Access Compliance Report

Public Rights-of-Way

(Curb Ramps)

Intersection ID: 10038783	Main Street: STEELE_CREEK_RD	Cross Street: N/A	Location: SW
ADA ID: 75DBF67D47CF	Ramp Type: PerpDiag	Initial Pass/Fail: Fail	Overall Compliance: No
Severity Score: 13.75			
Codes/Mitigation Info/Possible Solution		Field Measurements/Component Compliance

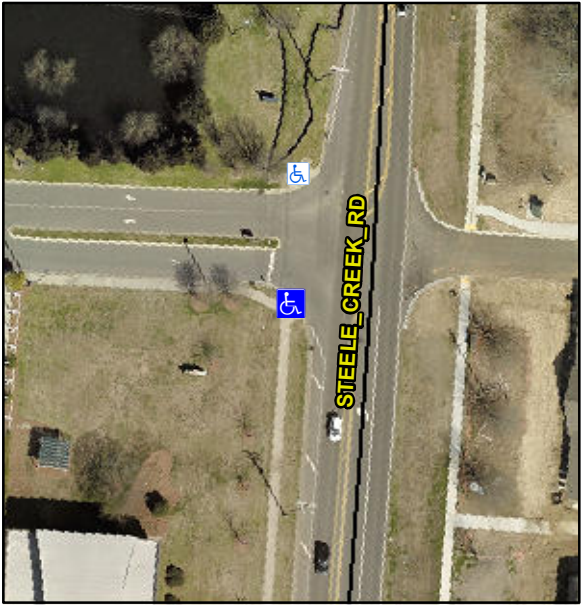
Possible Solutions:		Compliance	Description	Data	Compliance	Description	Data
	Remove & Replace Curb Ramp With Two New Directional Ramps or Equivalent.		N/A	Ramp Length (in)	46.0	No	Ramp Slope (%)	9.6
<p>Surveyor Notes:</p> <p>N/A</p> <p>PROW/ADA:</p> <p>Not Found, R304.2.2, R304.5.3</p>			Yes	Ramp Width (in)	48.0	No	Ramp XSlope (%)	3.6
			N/A	Flare Type LT	N/A	N/A	Flare Type RT	N/A
			N/A	Flare Slope LT (%)	N/A	N/A	Flare Slope RT (%)	N/A
			N/A	Flare Traversable LT?	N/A	N/A	Flare Traversable RT?	N/A
			N/A	Landing Length (in)	N/A	N/A	DWS Provided?	N/A
			N/A	Landing Width (in)	N/A	N/A	DWS Contrast?	N/A
			N/A	Landing Slope (%)	N/A	N/A	DWS Length (in)	N/A
			N/A	Landing X Slope (%)	N/A	N/A	DWS Full Width?	N/A
			N/A	Landing Curb? (Y/N)	N/A	N/A	DWS Offset (in)	N/A
			N/A	Shared Landing?	N/A			
			N/A	Gutter Ponding?	N/A	N/A	Gutter Slope (%)	N/A
			N/A	Gutter Lip Ht (in)	N/A	N/A	Gutter X Slope (%)	N/A
			N/A	Painted X Walk1?	No	N/A	Painted X Walk2?	No

X Walk 1 Direction	To E		X Walk 2 Direction	To N
			N/A	X Walk 1 Width (in)	N/A	N/A	X Walk 2 Width (in)	N/A
				X Walk 1 Slope (%)	3.0		X Walk 2 Slope (%)	0.2
				X Walk 1 X Slope (%)	0.9		X Walk 2 X Slope (%)	4.7
			N/A	Ramp inside XWalk1?	N/A	N/A	Ramp inside XWalk2?	N/A
				Road Slope (%)	3.1	N/A	Clear Space?	N/A
				Road X Slope (%)	4.7	N/A	Clear Space to XWalk (in)	N/A
			N/A	Any Obstructions?	N/A	N/A	Storm Grate/Utility Hazard?	N/A
				Obstruction Type			Storm Grate/Utility Type	
						N/A		N/A
						Yes	Surface Condition? (G/P)	Good
